## **MEMO**

**Subject:** Review of Water Right Application G-18980

## **Groundwater Application Review Summary Form**

Application # G- <u>18980</u>
GW Reviewer <u>Aurora C Bouchier</u> Date Review Completed: <u>6/19/2020</u>
Summary of GW Availability and Injury Review:
☐ Groundwater for the proposed use is either over appropriated, will not likely be available in the amounts requested without injury to prior water rights, OR will not likely be available within the capacity of the groundwater resource per Section B of the attached review form.
Summary of Potential for Substantial Interference Review:
$\square$ There is the potential for substantial interference per Section C of the attached review form.
Summary of Well Construction Assessment:
☐ The well does not appear to meet current well construction standards per Section D of the attached review form. Route through Well Construction and Compliance Section.
This is only a summary. Documentation is attached and should be read thoroughly to understand the

Comparison Hydrograph

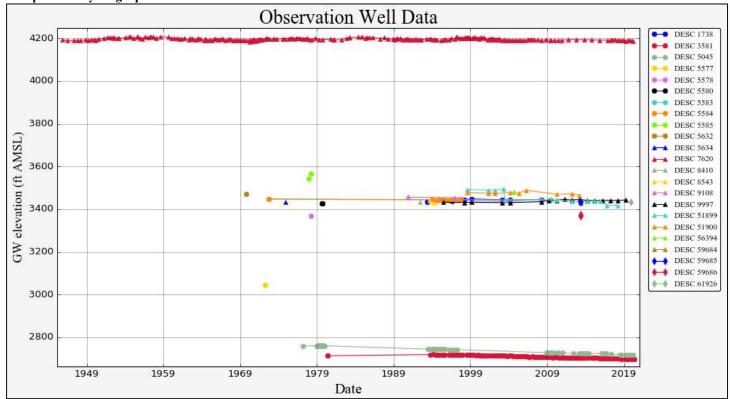
d.	☐ <b>Well reconstruction</b> is necessary to accomplish one or more of the above conditions. The problems that are likely to occur with this use and without reconstructing are cited below. Without reconstruction, I recommend withholding issuance of the permit until evidence of well reconstruction is filed with the Department and approved by the Groundwater Section.
		<b>Describe injury</b> —as related to water availability— that is likely to occur without well reconstruction (interference w/senior water rights, not within the capacity of the resource, etc):
В3.	Gro	oundwater availability remarks:
	simi	site is located within the Sisters Fault Zone, south of Awbrey Butte. As such, relevant observation wells should be ilarly located within the fault zone. Unfortunately, it appears that there are no long-term observation wells within this ion of the fault zone. There is no apparent trend in nearby wells.

stro	comparison sake, wells located up-gradient of the fault zones (i.e. DESC 7620 located in La Pine) continue to show a ng response to climate cycles through present. However, wells located down-gradient of the fault zones (i.e. DESC 3581 ted in Redmond and DESC 5045 located in Bend) show a persistent decline since the mid 1990's through present.
	proc	opears that the fault zone acts to retard the propagation of the groundwater decline. It is likely that addition groundwater duction within the USGS Deschutes Ground Water Study Area (DGWSA) will act to further exacerbate the groundwater ines seen down-gradient of the fault zones (Sisters and Brothers fault zones). However, the cumulative 200 cfs cap on

groundwater permits has not yet been reached (Division 690-505-0500).

Comparison Hydrograph

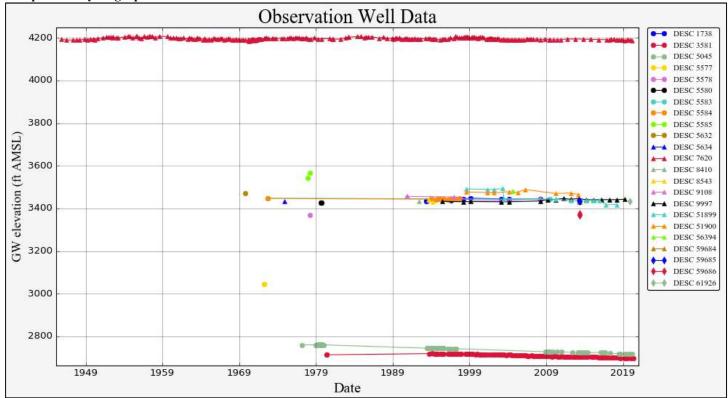
For comparison sake, wells located up-gradient of the fault zones (i.e. DESC 7620 located in La Pine) continue to show a strong response to climate cycles through present. However, wells located down-gradient of the fault zones (i.e. DESC 358) located in Redmond and DESC 5045 located in Bend) show a persistent decline since the mid 1990's through present.

It appears that the fault zone acts to retard the propagation of the groundwater decline. It is likely that addition groundwater production within the USGS Deschutes Ground Water Study Area (DGWSA) will act to further exacerbate the groundwater declines seen down-gradient of the fault zones (Sisters and Brothers fault zones). However, the cumulative 200 cfs cap on groundwater permits has not yet been reached (Division 690-505-0500).
